SERVICE BULLETIN

AMP-2/150-30-00 TORQUE SETTINGS

BULLETIN NUMBER: SB-0009
REVISION: A
DATE: MAR 2004

PRODUCT DESCRIPTION: VHF 30W POWER AMPLIFIER

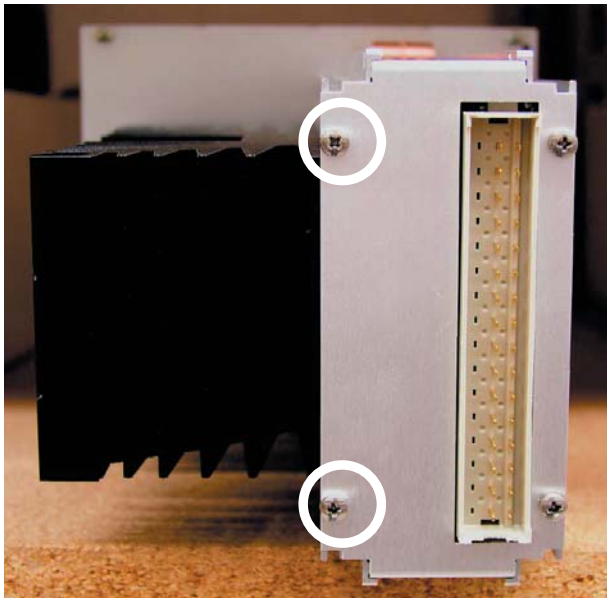
- 1 Remove four Front Panel screws.

- 2 Remove two screws at the back.

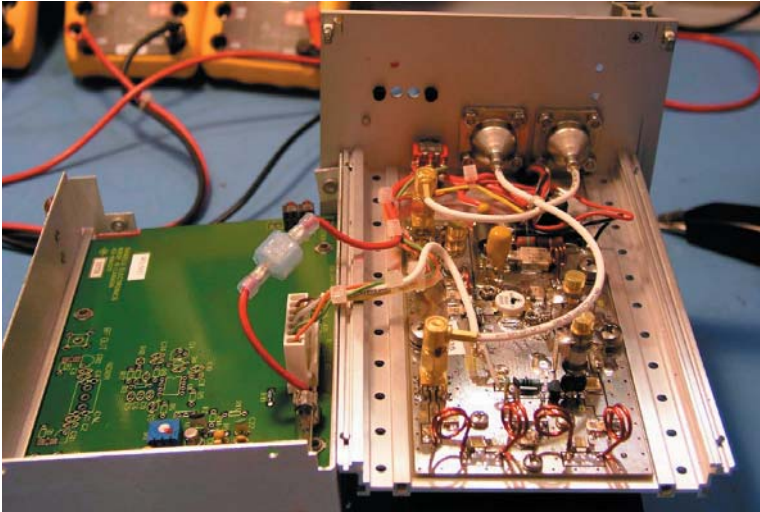
- 3 Open unit to expose the RF Amplifier board.

- 4
 - Check that the two Hex Sock Screws have been tightened. The correct torque setting for these screws is 90 in/oz.
 - Check that the four M5x12 P/P screws holding the PCB to the side panel and into the heatsink, have been tightened. The correct torque setting for these screws is 400 in/oz (25 in/lb)
